### Resource consent application – Further information request

Application number(s):	BUN60427502
Applicant:	JAMES KIRKPATRICK GROUP LIMITED
Address:	538 Karangahape Road NEWTON 1010
Proposed activity(s):	To construct and operate a new part 10- part 11-level commercial building with two basement levels. Bulk cut earthworks with associated groundwater drawdown and diversion. The proposal is located on a HAIL site and a contaminated land discharge consent is required.

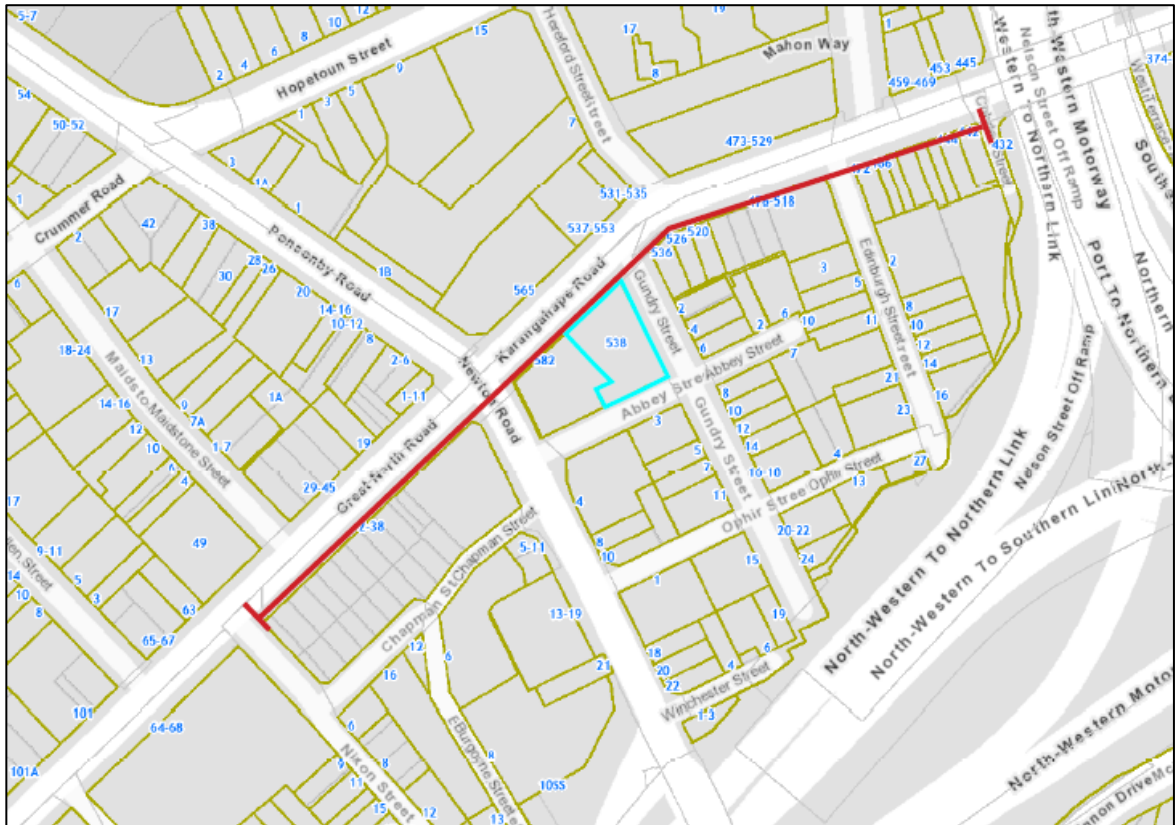
- 2) Standard H8.6.26.(5)(a) states that verandahs must have a maximum height of 4m above the footpath immediately below. It appears from measurements taken off the plans that there are sections of the verandah that are higher than 4m above the footpath. Please

confirm the height and include this on the plans. If there is an infringement please apply for this and provide the assessment.

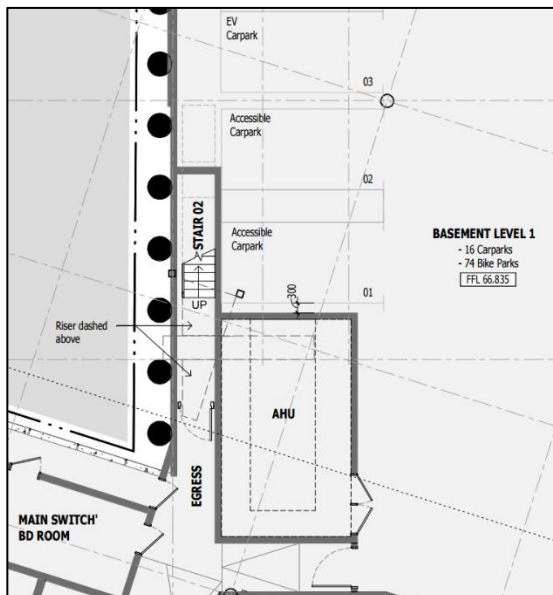
- 14) The scope of the study area adopted for the crash analysis and the spread of crashes throughout the study area are not entirely clear from the information provided in the Transport Assessment (TA). While the TA references particular intersections covered in the analysis, it is not clear as to whether the analysis covers a sufficiently wide area, including mid-block sections of road.

The proposal is expected to result in high concentrations of new vehicle activity at the intersection of Karangahape Road / Gundry Street and high concentrations of pedestrian activity at this intersection and at the new pedestrian building entrances on Karangahape Road and Abbey Street. An appropriate scope for the crash analysis should therefore include:

- a. Karangahape Road between (and inclusive of) its intersections with Newton Road and Edinburgh Street, noting that there are no formalised intermediate pedestrian crossing opportunities between these two intersections.
- b. Gundry Street, at least as far south as its intersection with Abbey Street
- c. Abbey Street, between Newton Road and Gundry Street

Please provide further detail accordingly and if appropriate, consider scope for mitigation measures, such as additional pedestrian crossing points to cater for desire lines accessing the new development.

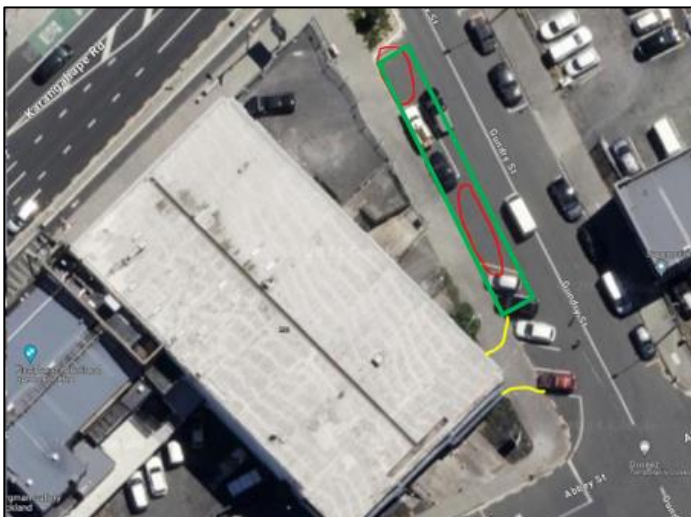
*Advice note: all four redundant vehicle crossings will need to be reinstated by the applicant to the kerb, channel and footpath. The No Stopping at Any Time line markings in front of the redundant Abbey Street vehicle crossings will need to be removed by the applicant. It is recommended that these reinstatement requirements are accepted as a condition of consent with the design detail considered at subsequent design stages. Anticipated required changes to the western side of Gundry Street (along the site's frontage) include:*

- *The removal of angled parking spaces to allow for the vehicle crossing,*
- *Reinstatement of both redundant vehicle crossings on Gundry Street,*
- *Provision of angled parking from the northern kerb buildout to the proposed vehicle crossing without adversely effecting visibility for vehicles leaving the site.*
- *It is likely that the applicant is requested to remove the existing motorbike parking bay.*

*The image below illustrates a concept of how the reconfiguration could work, with the green bar indicating AT's preferred space for paid angled parking. Please note this figure is for reference only to guide a design by the applicant, and it does not indicate that a similar design will be approved in future.*

*AT has requested that the applicant agree to the reinstatement mentioned above, with a concept design being submitted. This would assist in streamlining the EPA process.*

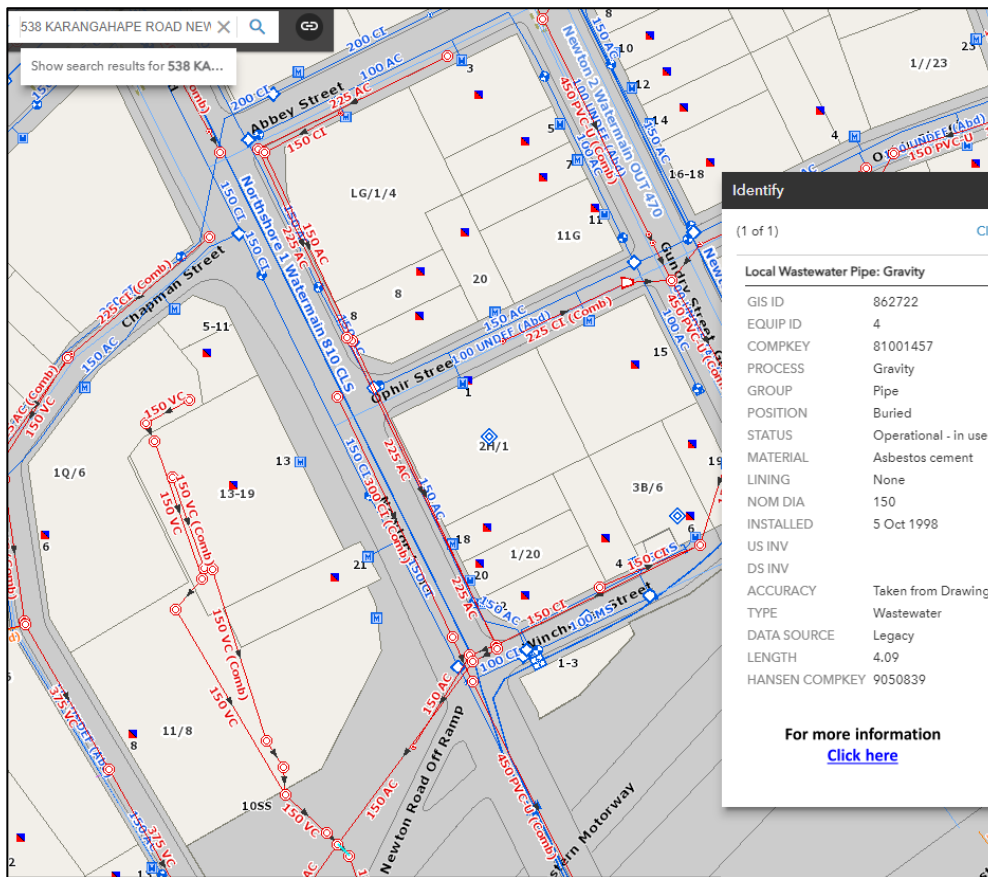
- 28) The existing stormwater line shown on the proposed drainage plan does not match up with information on the Council's GIS. Please confirm if existing SWMH 1 is SWMH ID 2000730938 and update drawing for consistency.

- 29) Similarly, the existing wastewater line does not align with the information on Council's GIS. It is noted that the Infrastructure Report states that the "*[s]ite investigation undertaken by Maven Associates has confirmed that the wastewater line does not exist in the berm, and we believe that the line is within the Abbey Street carriageway. The manhole lid is cracked, and a service request has been lodged with Watercare (ref SR 10062208 #4417696). Until this is resolved, Maven is unable to confirm invert depth, or confirm if this asset exists*". Please indicate if this has been resolved and if the connection point has been confirmed / identified. If so, please update the wastewater line and clarify the proposed wastewater extension arrangement. Also add the proposed and existing wastewater items to the legend.
